HIAWATHA COAL COMPANY

Re: Response To Deficiencies Task 4333, Hiawatha Coal Company, C/007/0011

Title: Pond 5A Temporary Access Road

Access Road to allow for the extraction of Coal Fines from Slurry Pond 5A

EXHIBIT
8-1A

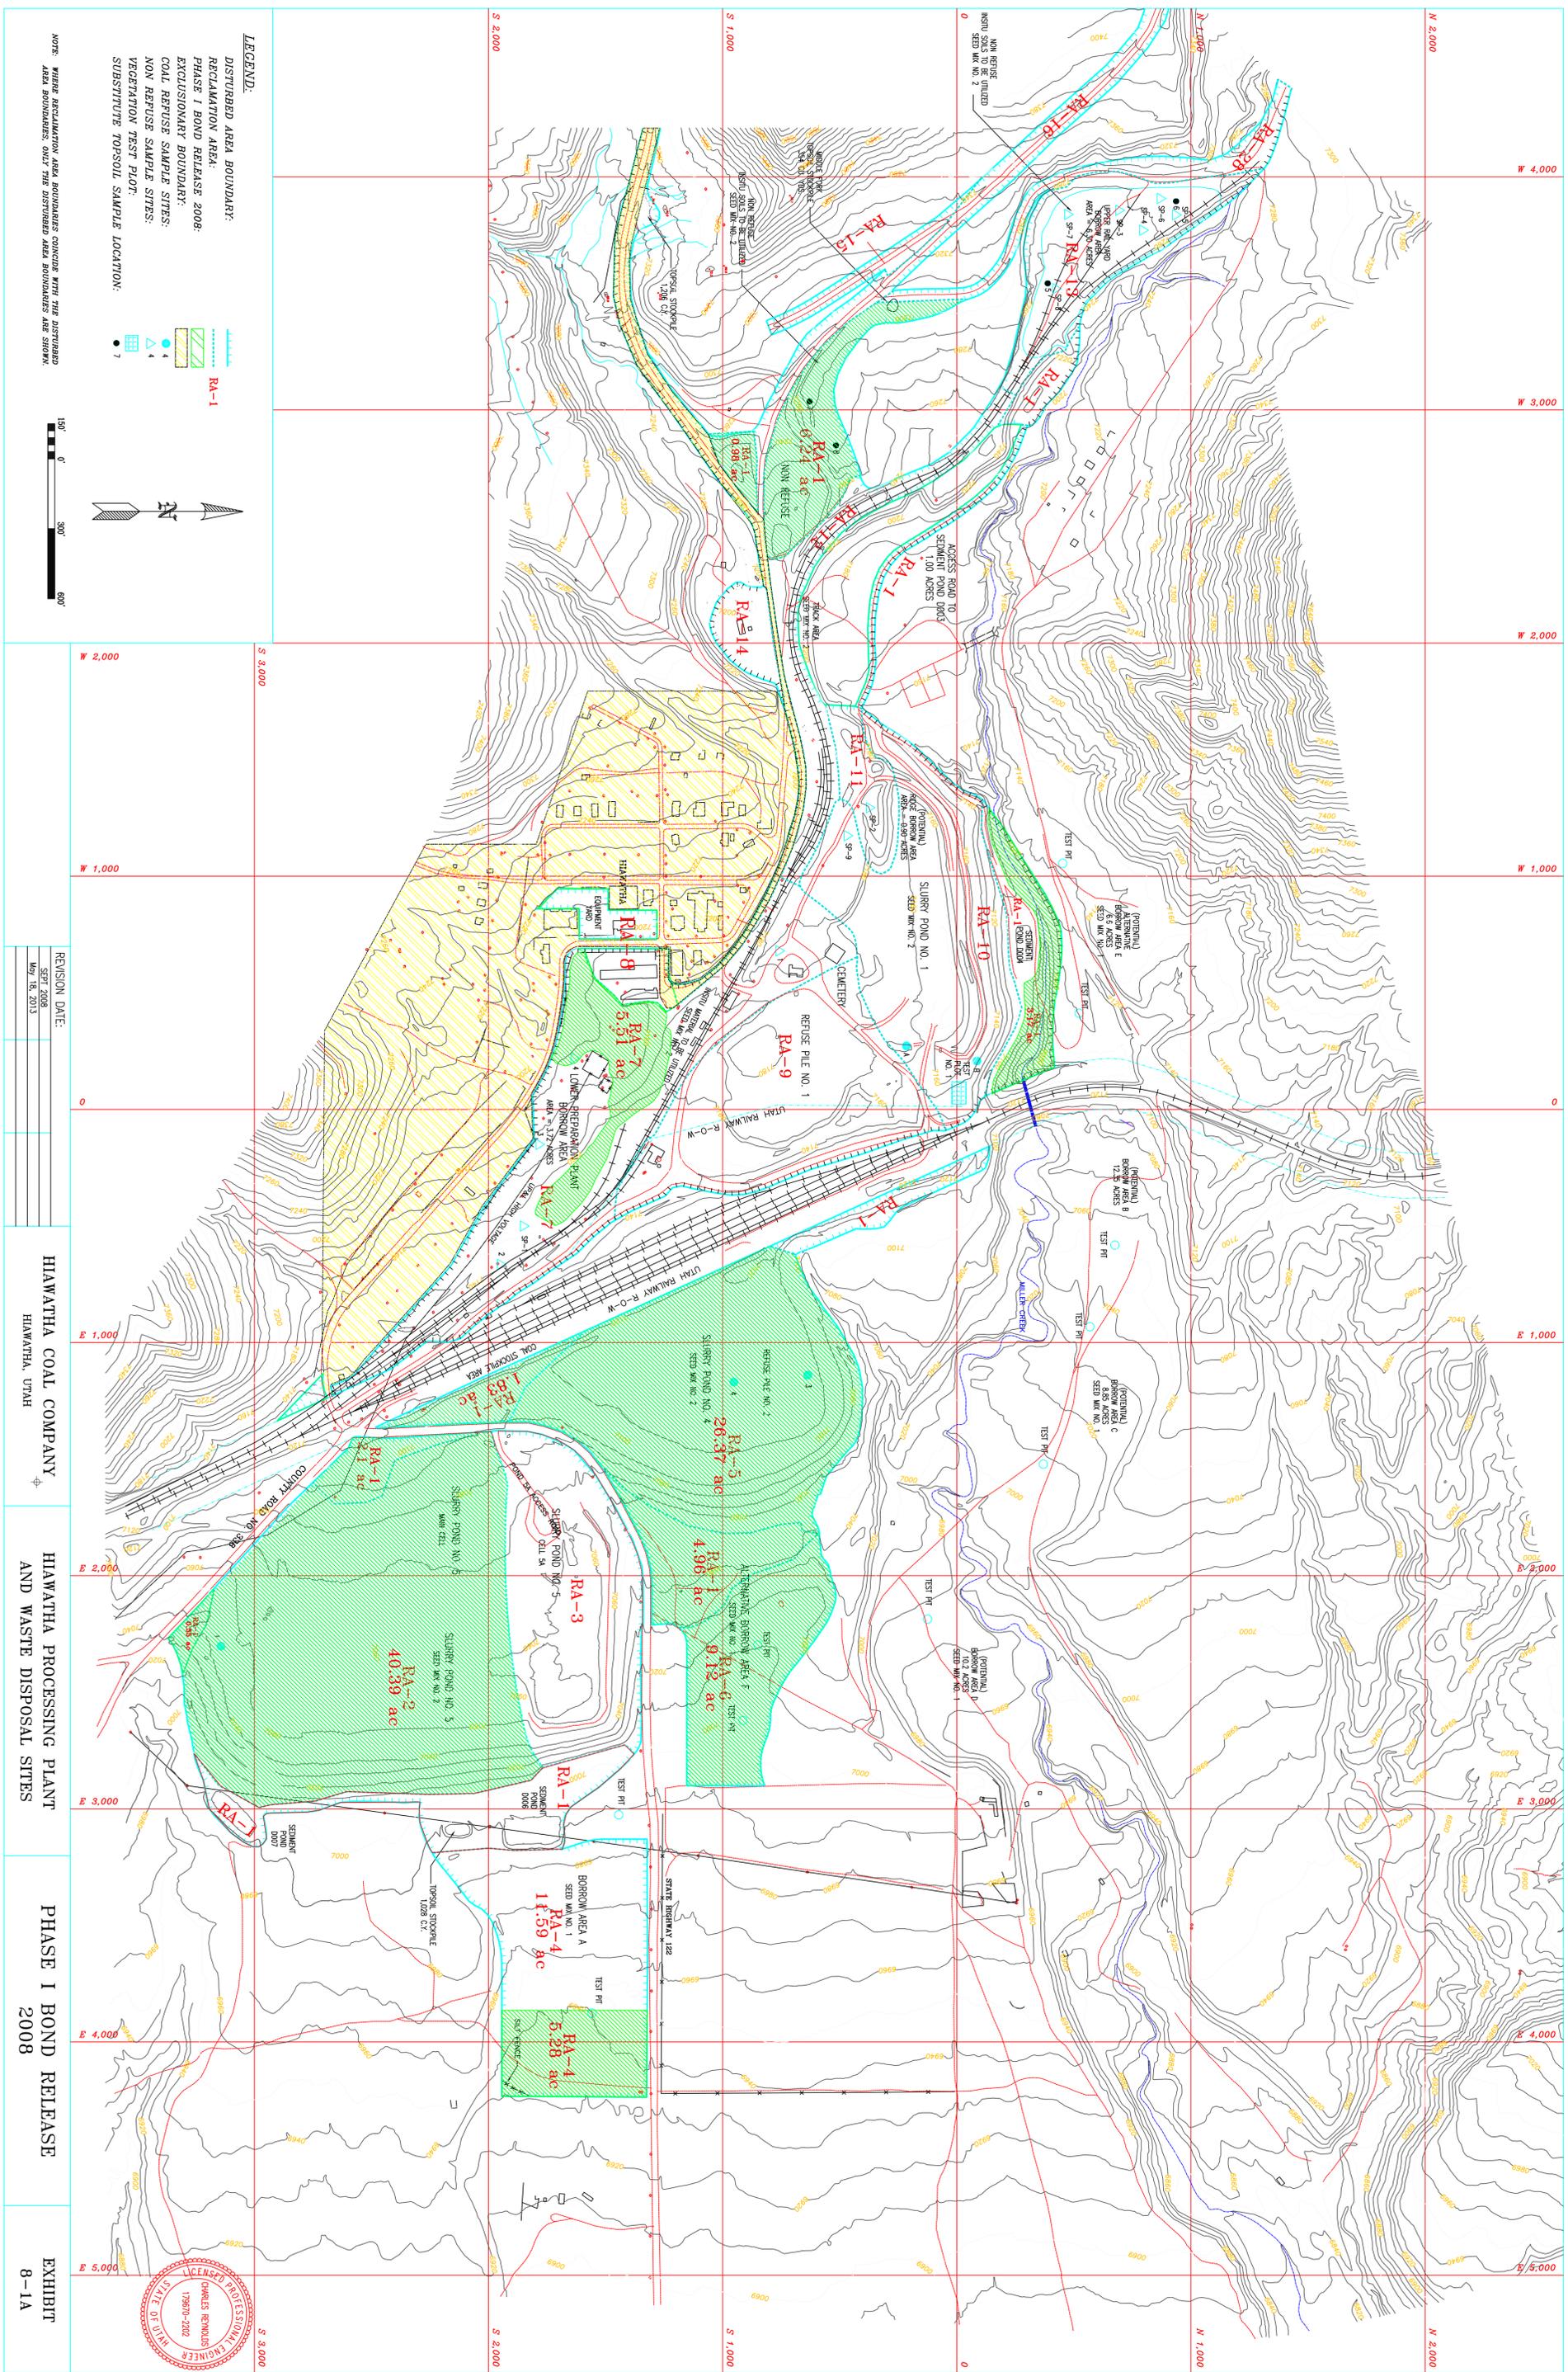
R645-301-521.165 & 270 – Appendix 5-17 addresses the deficiencies in these sections. Exhibit 8-1A has also been updated to clarify the reclaimed area boundary.

R645-301-527.200 – Exhibit 8-1A and Appendix 5-17 have been revised to address the confusion under this section.

Figure V-17A

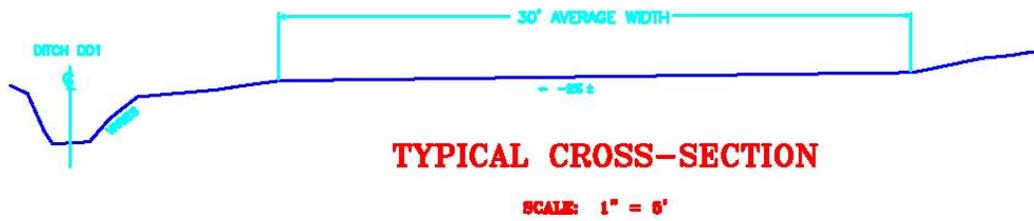
R645-301-121.200 – Appendix 5-17 has been added showing design information.
